Relay Board Assembly (0521B-000)

FOR USE WITH MODELS: CV-350, CV-350C, CV-353,
 CV-353C, CV-400, CV-400C

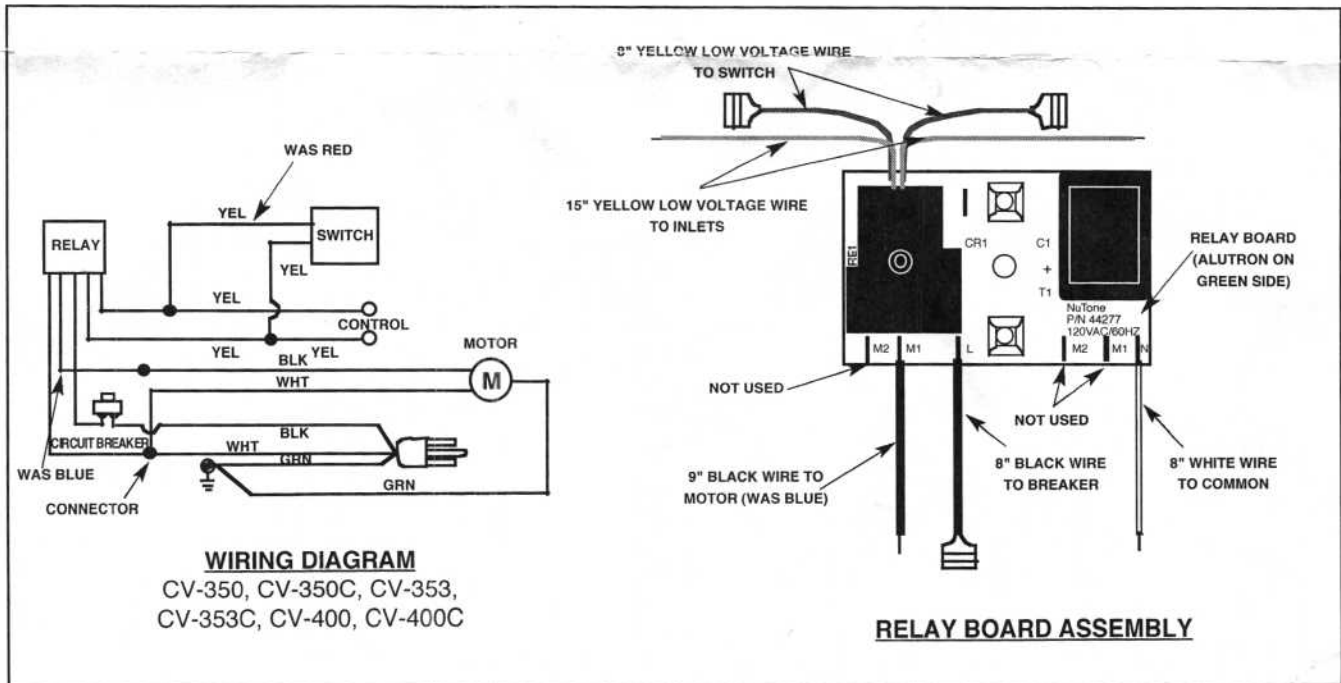
The relay assembly you are replacing may not have the same appearance as the new assembly. Please note the following changes:

1. The blue power lead wire has been changed to a black lead wire.
2. The red lead wire connected to the switch has been changed to a yellow lead wire.
3. For models manufactured after May 1997, two additional yellow lead wires are provided. If your power unit was manufactured prior to May 1997 and if these lead wires are not used, remove each lead from the terminal connection.

Warning: Disconnect electrical supply before servicing unit. Failure to do could result in serious injury or death. Disconnect old lead wires and reconnect per the wiring diagram below.
